STATE OF MAINE
DEPARTMENT OF TRANSPORTATION
16 STATE HOUSE STATION
AUGUSTA, MAINE 04333-0016

November 18, 2022
Subject: Bridge Rehabilitation
State WIN: 021751.01
Location: **Boothbay Harbor & Southport
Amendment No. 5**

OF 48

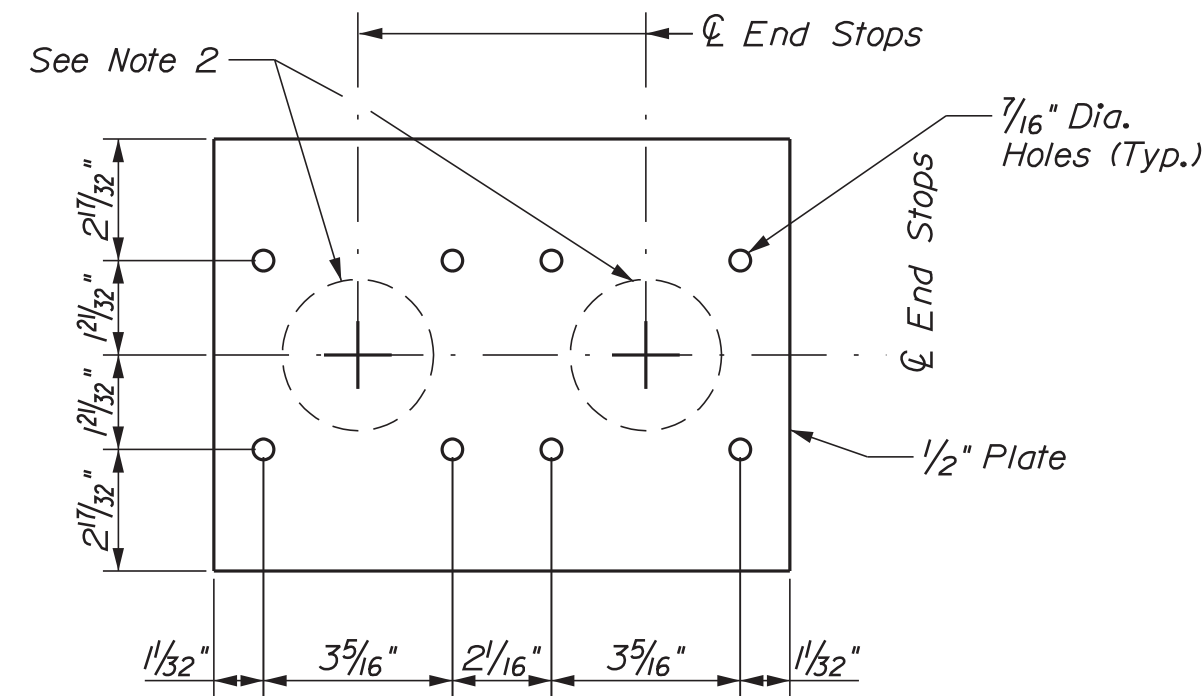
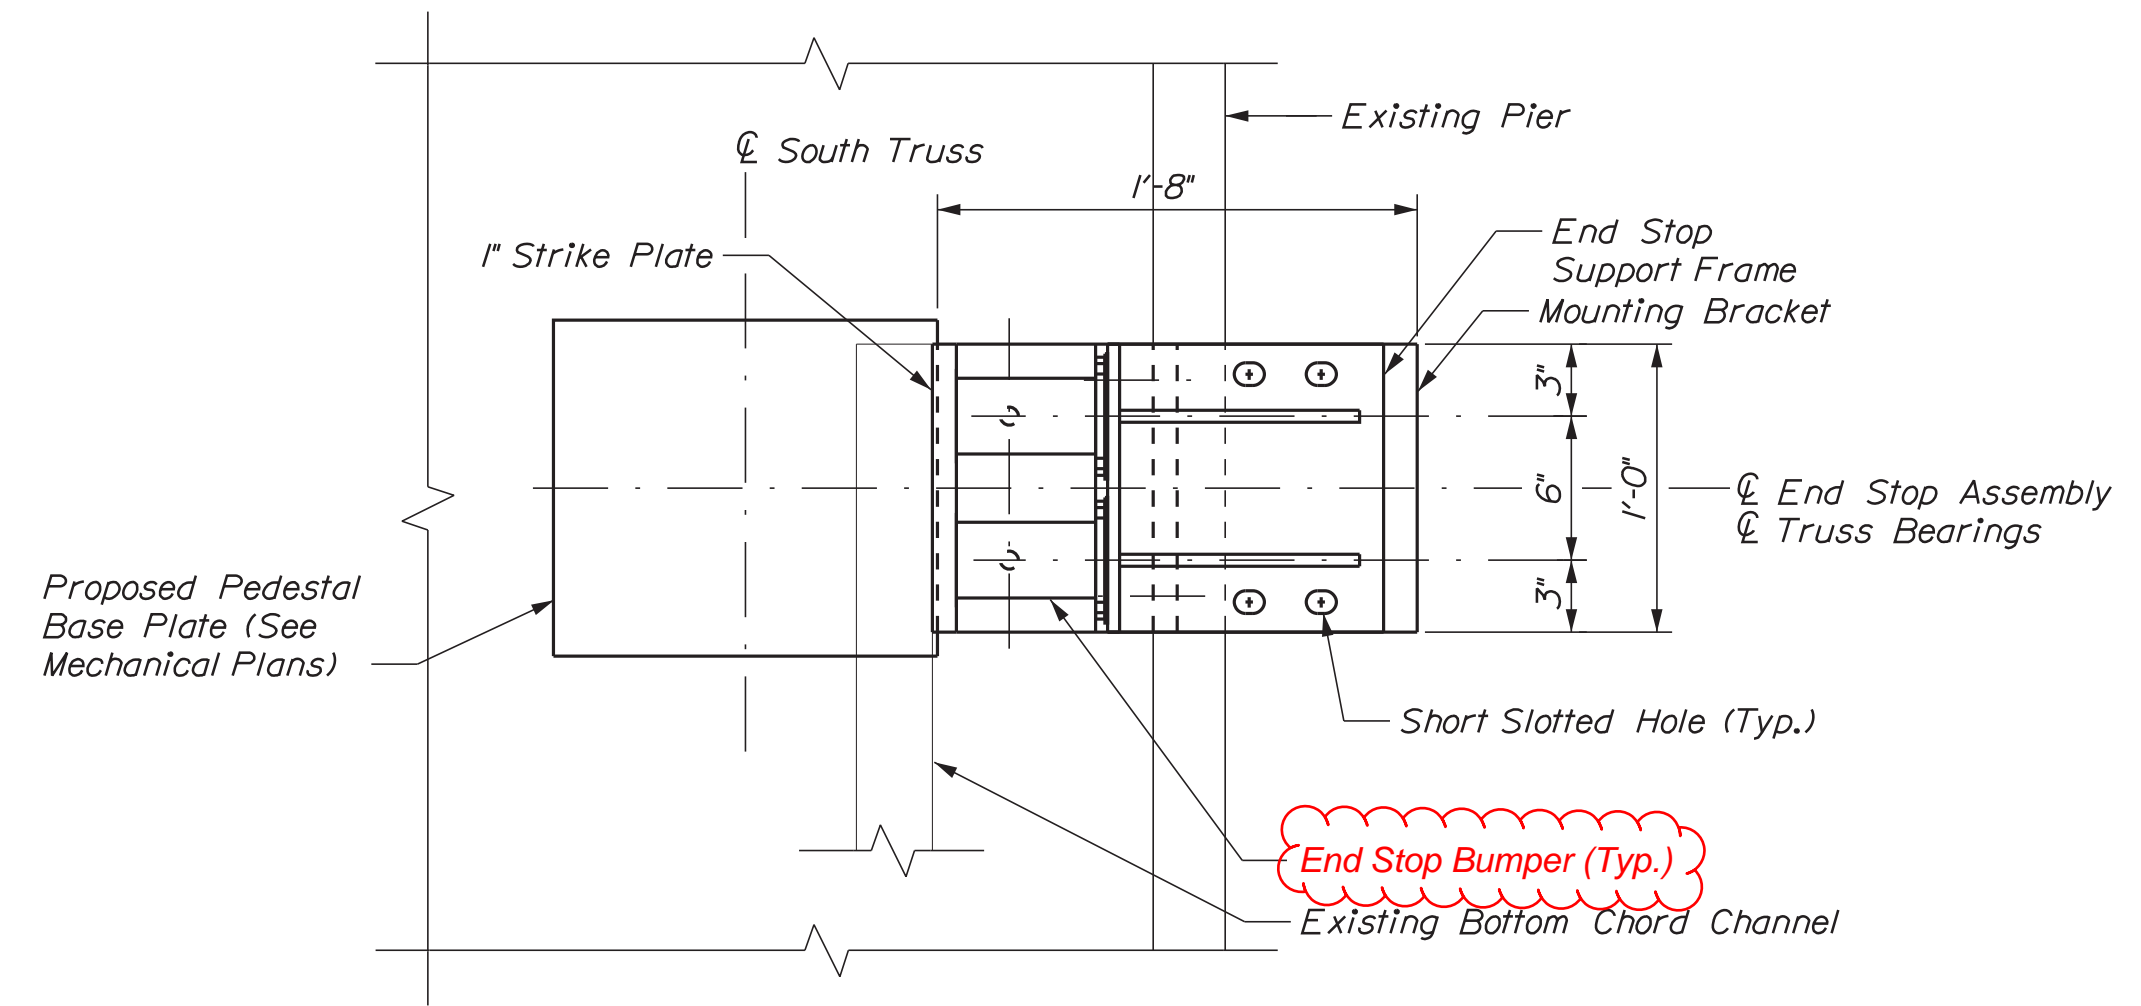
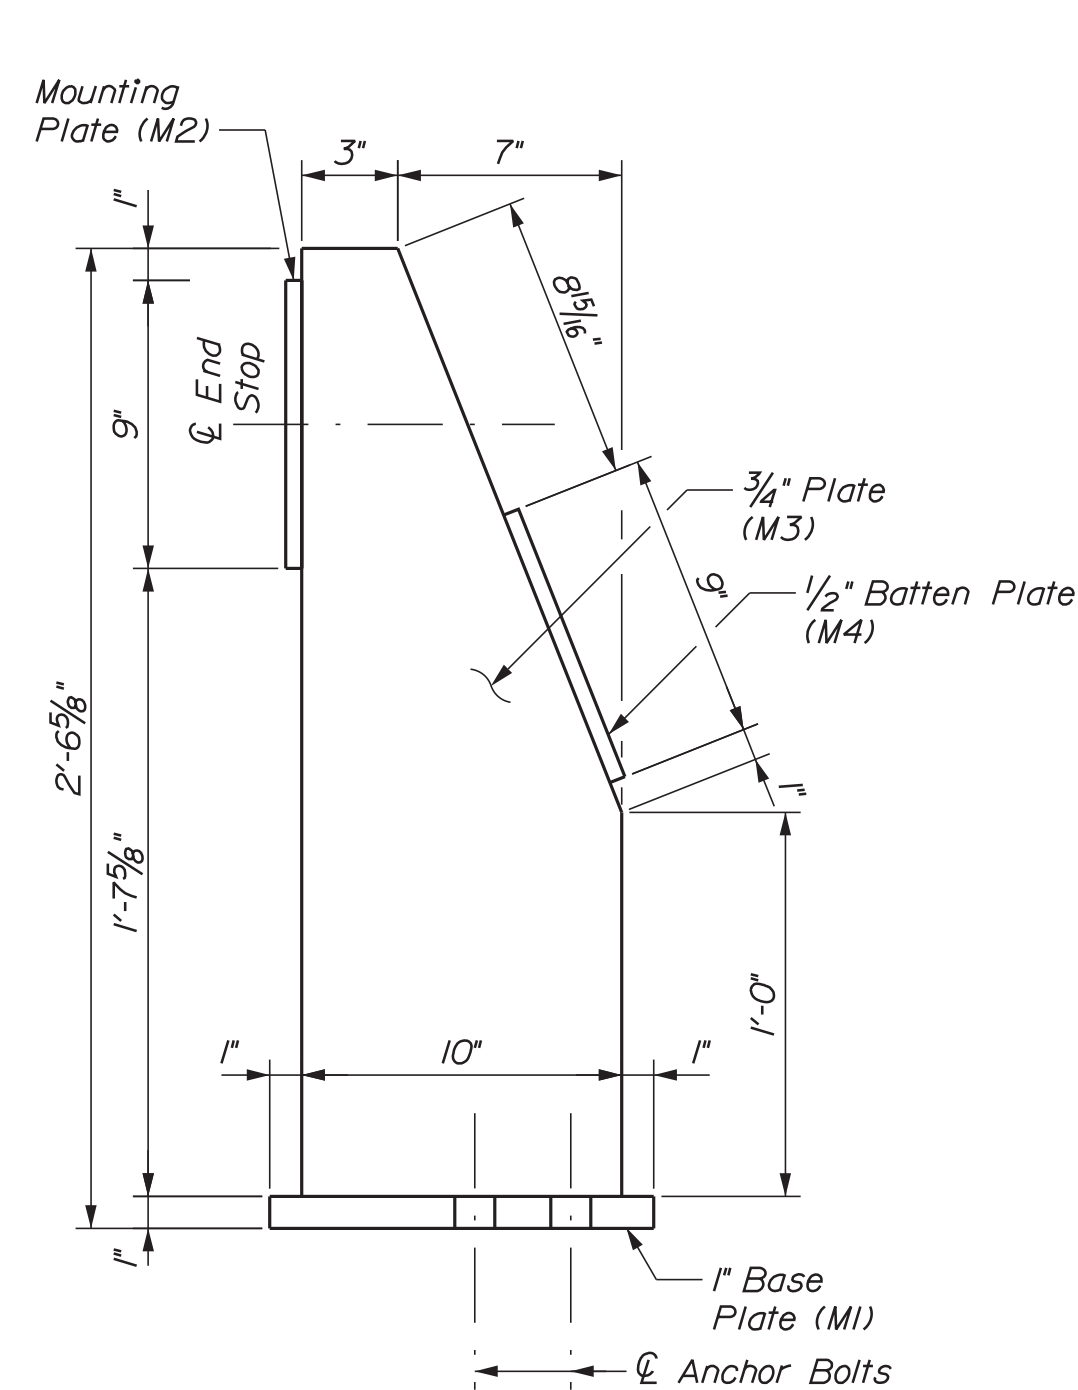
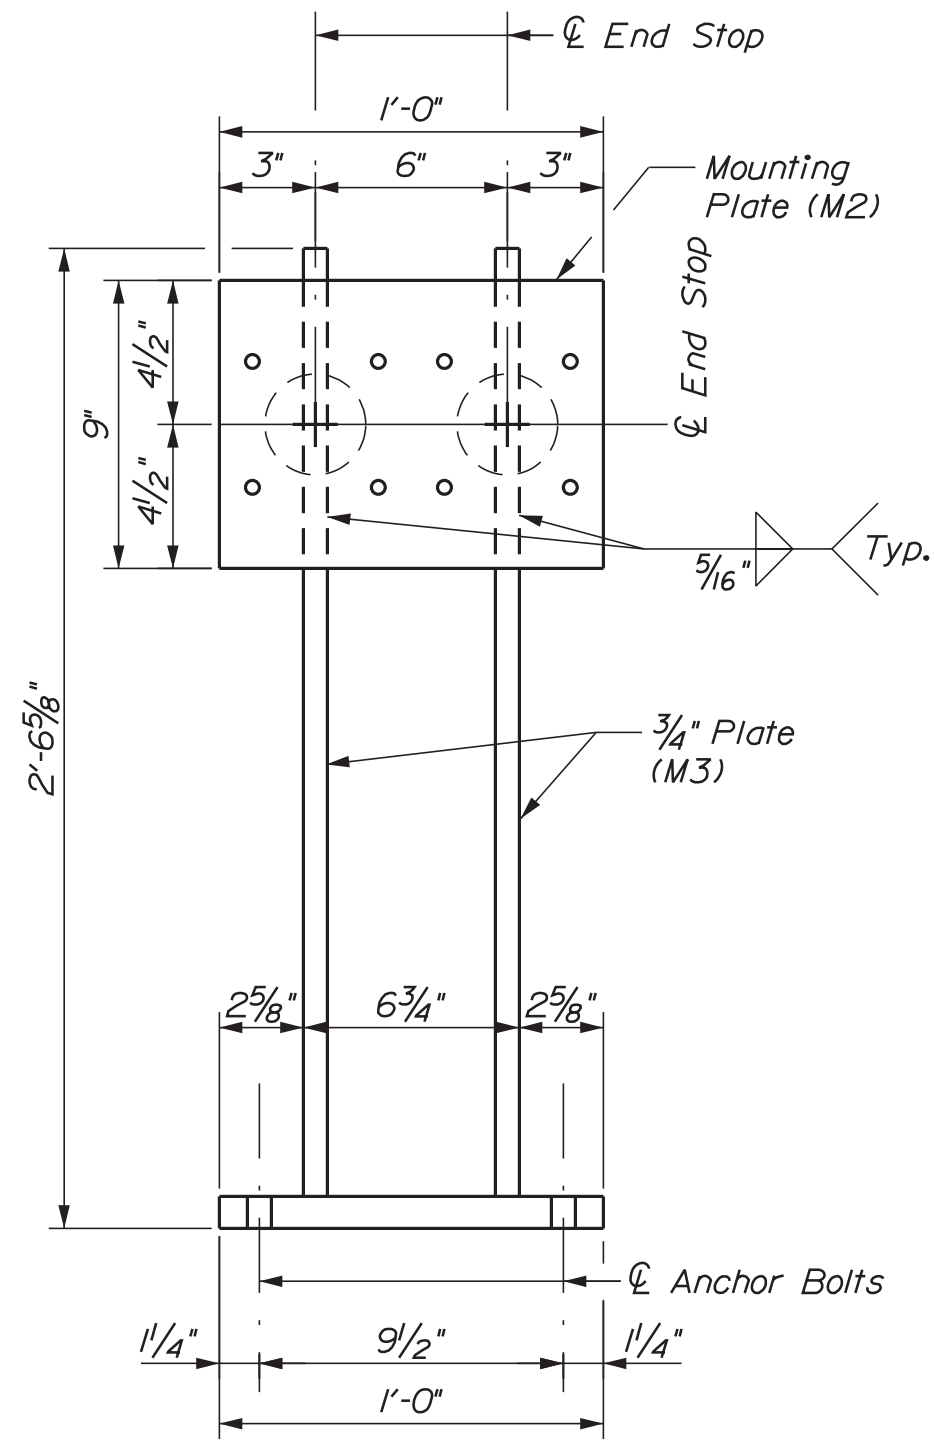
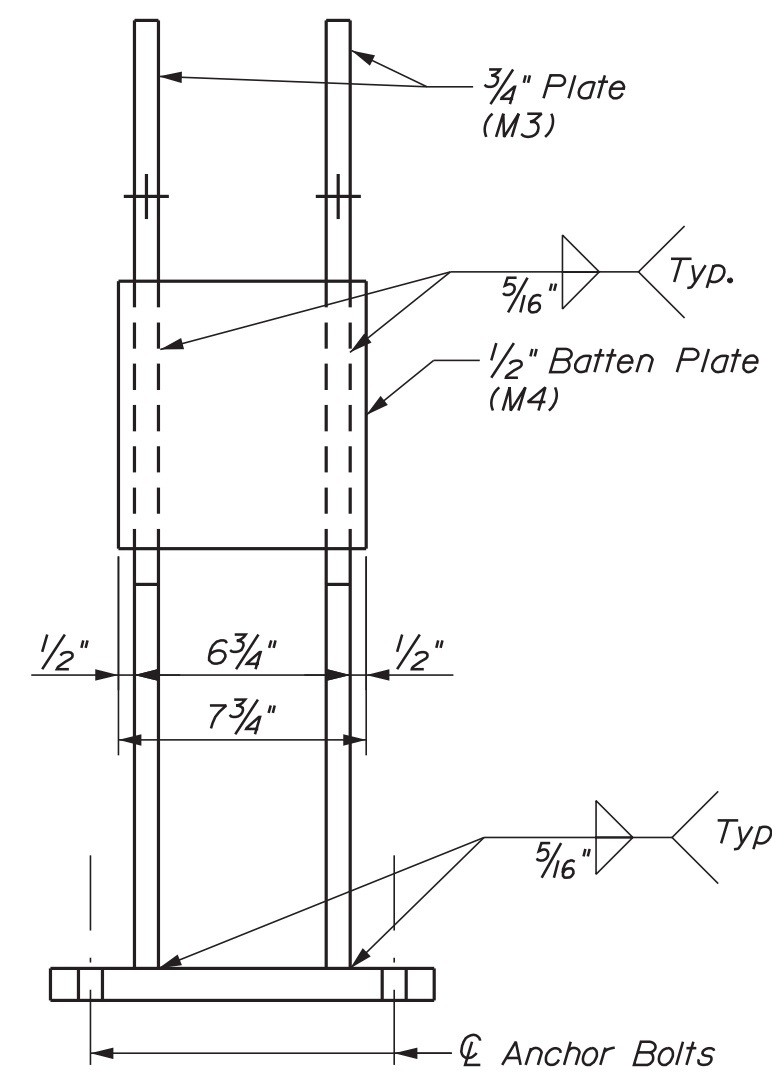
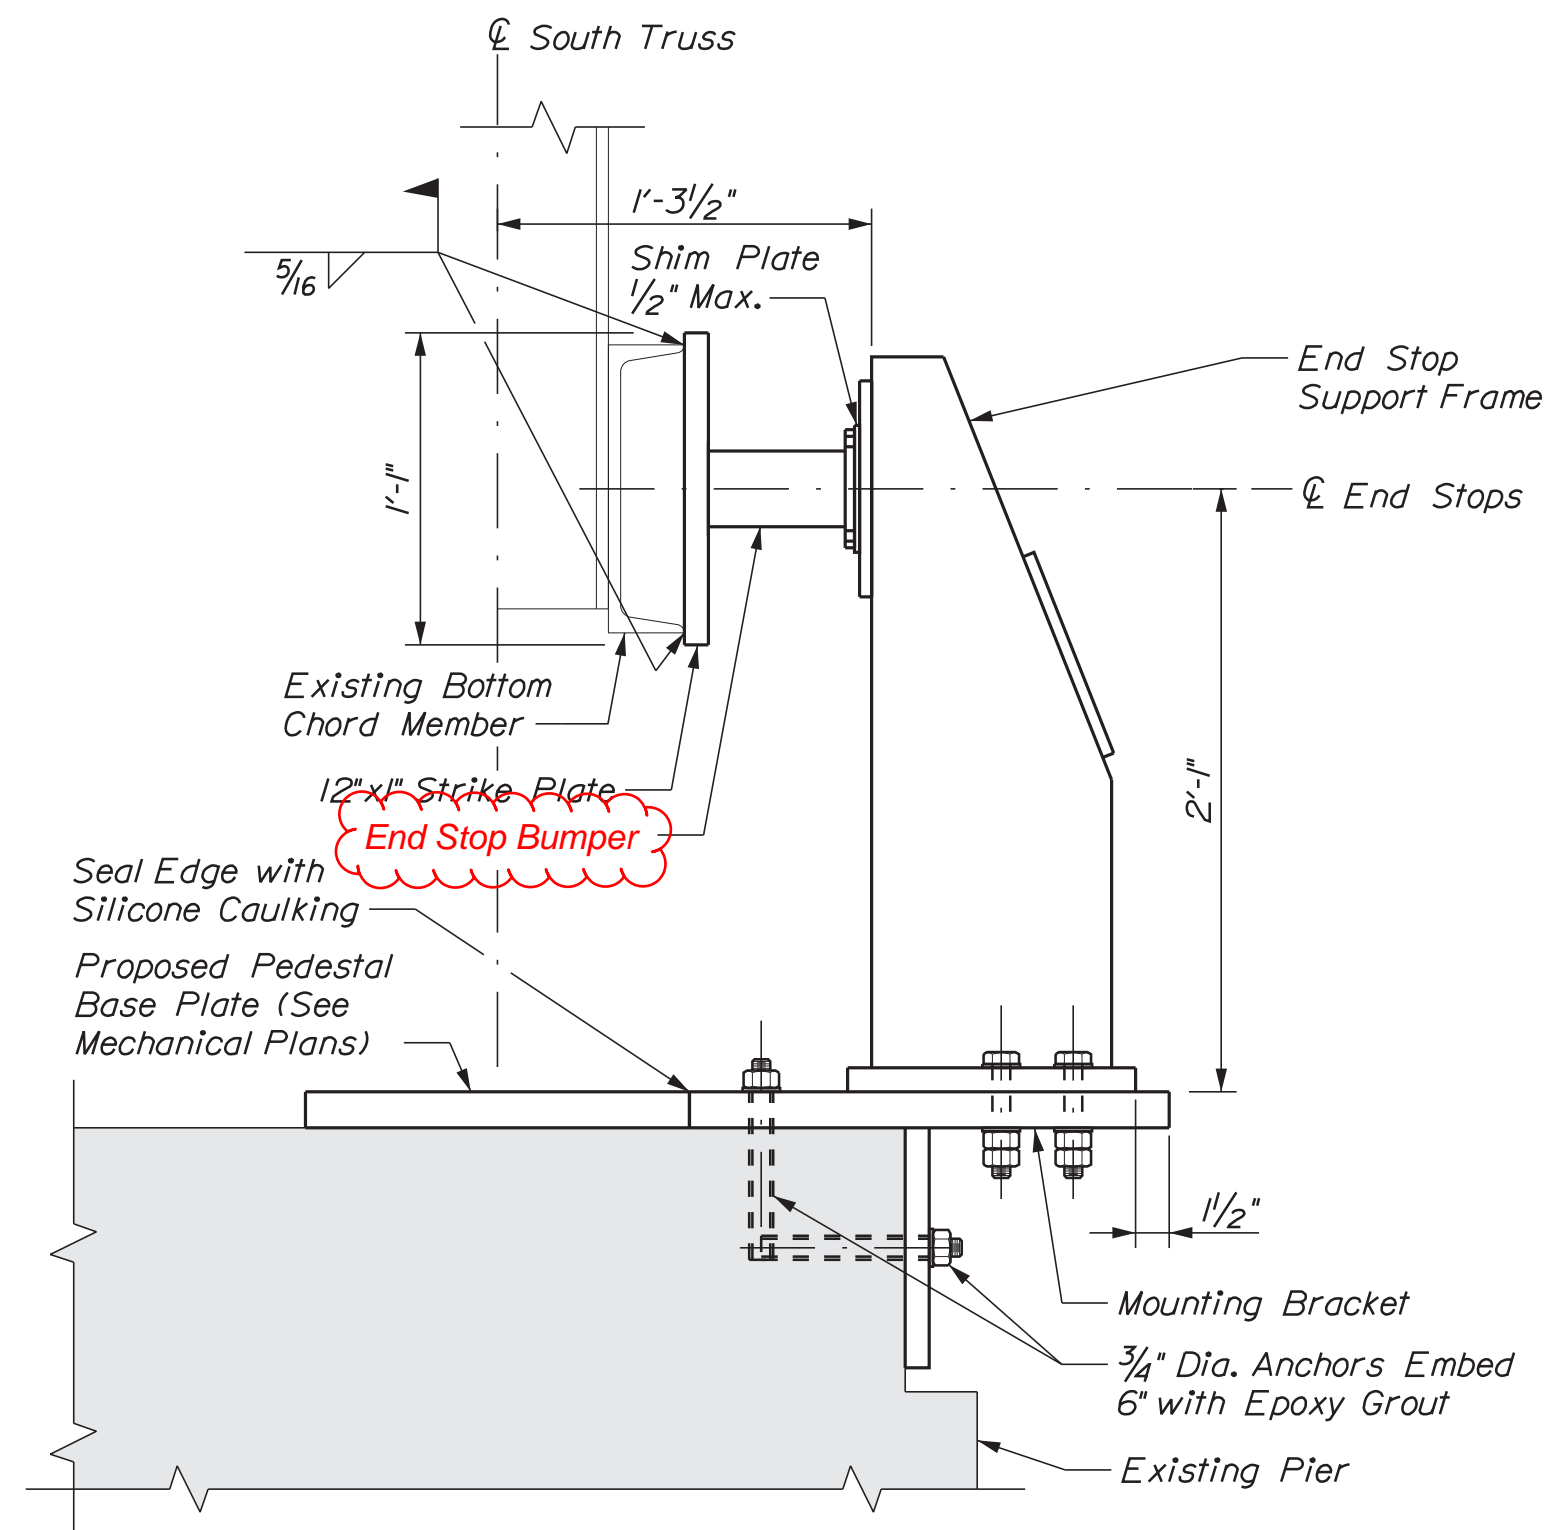
Question: On Drawing 25 for the End Stop there is unidentified material shown between the 12X1" Strike Plate and another unidentified plate. Special Provision 860.16 indicates Stop Assembly to be provided "as depicted on Contract Plans", but the polyurethane bumper described in the SP is not actually identified on the plans. Please clarify/specify the location, size, shape, and construction of the polyurethane bumper/plate assembly required.

Response: Sheet 25 of 48 has been revised to clarify the location of Polyurethane Bumper called for in Special Provision 860.16. The Polyurethane Bumper that the design is based on is a high-performance industrial bumper that is 80 mm in diameter x 80 mm long on an integral 100 mm x 100 mm x 10 mm mounting plate.
